ITEM FOR ENVIRONMENTAL COMMISSION AGENDA

COMMISSION MEETING DATE:	August 16th, 2022
NAME & NUMBER OF PROJECT:	Case No. C814-2008-0136.02 (North Austin Medical Center PUD Amendment #2)
NAME OF APPLICANT OR ORGANIZATION:	Michael Whellan, Armbrust & Brown
LOCATION:	12221 N Mopac Expressway Service Road NB Austin, Texas 78758
COUNCIL DISTRICT:	District 7
ENVIRONMENTAL REVIEW STAFF:	Leslie Lilly, Environmental Program Coordinator, Watershed Protection Department, Leslie.Lilly@austintexas.gov
WATERSHED:	Walnut Creek Watershed, Suburban Watershed
REQUEST:	To amend a Planned Unit Development (PUD)
STAFF RECOMMENDATION:	Staff recommended with conditions
STAFF CONDITIONS:	<ol style="list-style-type: none">1. The project will provide water quality controls to treat all existing and new development proposed for the south tract (14.94 acres total) including a new biofiltration pond to treat 10.8 acres of that area.2. The proposed development will eliminate the removal of 111 trees, 20 protected size-class trees.3. This project will use alternative water sources to meet irrigation demands4. The project will collect rainwater with a volume equal to one inch times the roof area in a 40,000 gallon

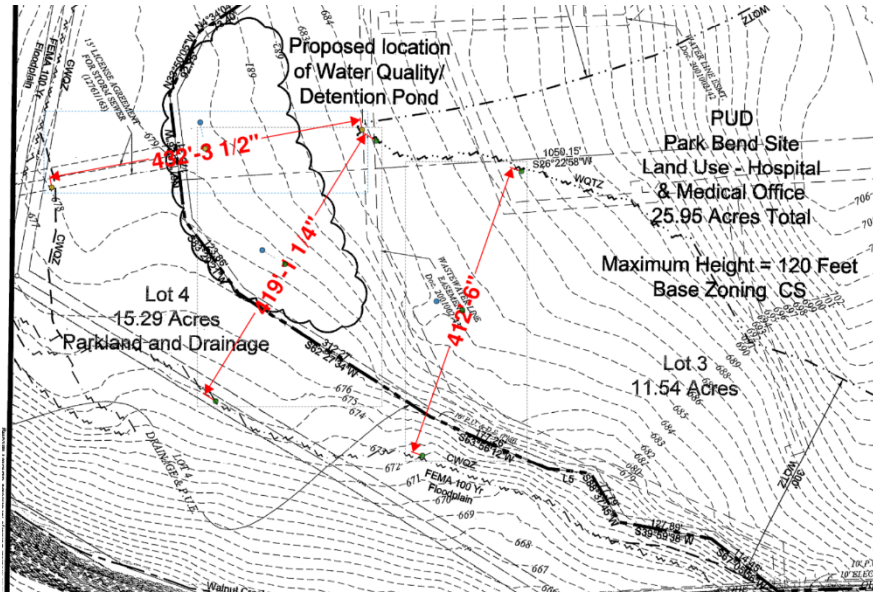
G.1.b. is technically under Austin Water Forward plan which has more to do with quantity of water used not quality of water quality defined by environmental pollutant loads. Not sure this is the best section to put this information under.

G.1.c is also not really required since BMP is outlined in the ECM and 1 stated that the WQ pond would comply with COA requirements.

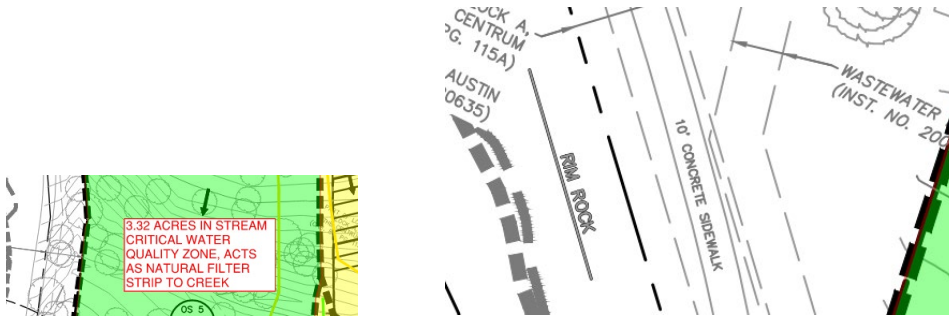
EO1 Update1: Please label CWQZ, CEF/CEF setbacks and location of creek center line on Exhibit B.

EO2 Update1: Comply with current code regarding CWQZ setbacks and protections.

EO3 Update1: Provide an exhibit showing the original 21.55 acres of drainage area intended for water quality treatment by the approved pond configuration. In the exhibit, clarify how the approved 21.55 acres of drainage area differs from the proposed 13.65 areas of drainage area using different colors or hatching to differentiate between the two areas.

Response: Critical Water Quality Zone (CWQZ), Critical Environmental Feature (CEF) and Walnut Creek lines and setbacks are shown and labeled. CWQZ and WQTZ comply with 2008 regulations and are defined by PUD Ordinance No. 20100624-109, Exhibit B: Land Use Plan.

Response: Critical Water Quality Zone (CWQZ), Critical Environmental Feature (CEF) and Walnut Creek lines and setbacks are shown and labeled. CWQZ and WQTZ comply with 2008 regulations and are defined by PUD Ordinance No. 20100624-109, Exhibit B: Land Use Plan.

Response: Separate exhibits and an overlay have been prepared and attached with this submittal for review.
